# Access Compliance Report

## Public Rights-of-Way

Intersection ID: 31220	Main Street: OAKTON_HUNT_DR	Cross Street: CAPRINGTON_AV	Location: N
ADA ID: 5A2720548354	Ramp Type: PerpDiag	Initial Pass/Fail: Fail	Overall Compliance: No
			Severity Score: 46.25

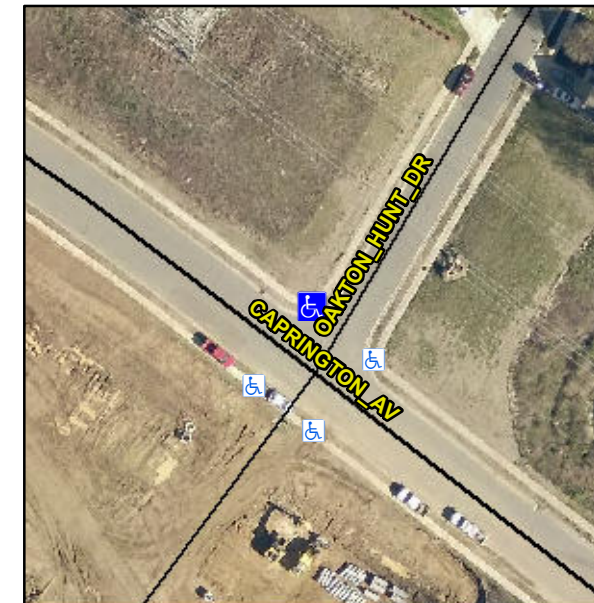
**Not Found, R304.5.1, R304.2.2, R304.5.3**

Compliance	Description	Data	Compliance	Description	Data
N/A	Ramp Length (in)	48.0	No	Ramp Slope (%)	9.3
No	Ramp Width (in)	43.0	No	Ramp XSlope (%)	11.5
N/A	Flare Type LT	N/A	N/A	Flare Type RT	N/A
N/A	Flare Slope LT (%)	N/A	N/A	Flare Slope RT (%)	N/A
N/A	Flare Traversable LT?	N/A	N/A	Flare Traversable RT?	N/A
N/A	Landing Length (in)	N/A	N/A	DWS Provided?	N/A
N/A	Landing Width (in)	N/A	N/A	DWS Contrast?	N/A
N/A	Landing Slope (%)	N/A	N/A	DWS Length (in)	N/A
N/A	Landing X Slope (%)	N/A	N/A	DWS Full Width?	N/A
N/A	Landing Curb? (Y/N)	N/A	N/A	DWS Offset (in)	N/A
N/A	Shared Landing?	N/A			
N/A	Gutter Ponding?	N/A	N/A	Gutter Slope (%)	N/A
N/A	Gutter Lip Ht (in)	N/A	N/A	Gutter X Slope (%)	N/A
N/A	Painted X Walk1?	No	N/A	Painted X Walk2?	No
	X Walk 1 Direction	To SW		X Walk 2 Direction	To SE
N/A	X Walk 1 Width (in)	N/A	N/A	X Walk 2 Width (in)	N/A
	X Walk 1 Slope (%)	5.8		X Walk 2 Slope (%)	4.9
	X Walk 1 X Slope (%)	4.2		X Walk 2 X Slope (%)	3.7

**Remove & Replace Curb Ramp With Two New Directional Ramps or Equivalent.**
